LCDX4-14AF-L
Copper Lug - Two-Hole, Standard Flex Barrel, 90° Angle Tongue

SCALE N/A DRAWING NO / CAD FILE LCDX4-14AF-CUST

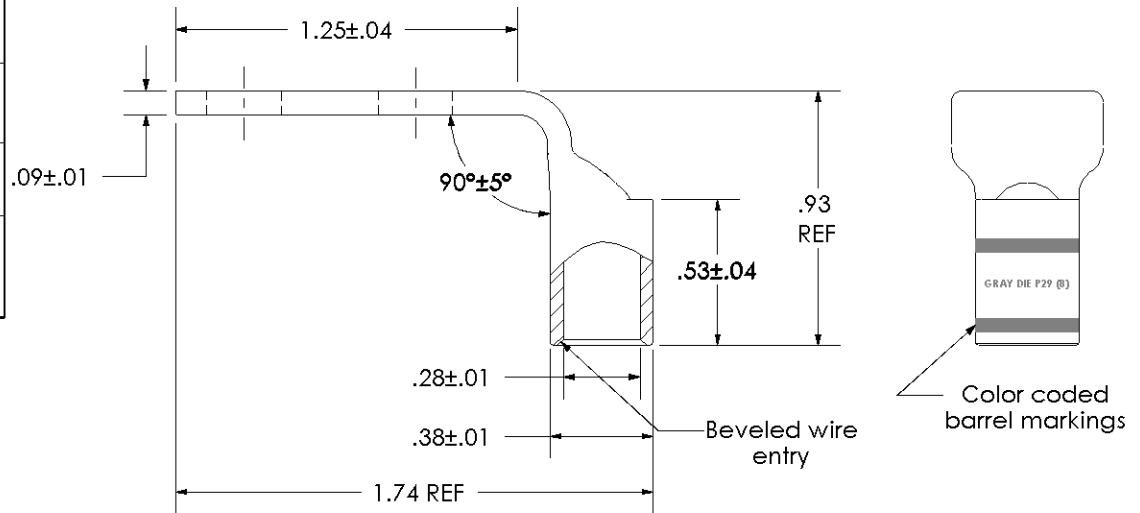
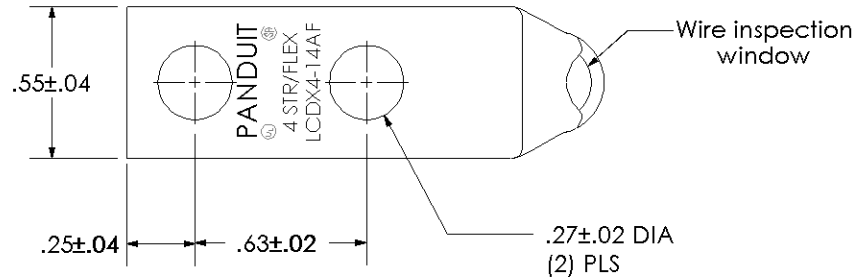
01	3/04	KLFU	TLCO	WIRE SIZE WAS: 4 STR/FLEX ADDED 3 & 5 FLEX, LOCOMOTIVE ONLY * NOTE	11610
REV	DATE	BY	CHK	DESCRIPTION	ECN
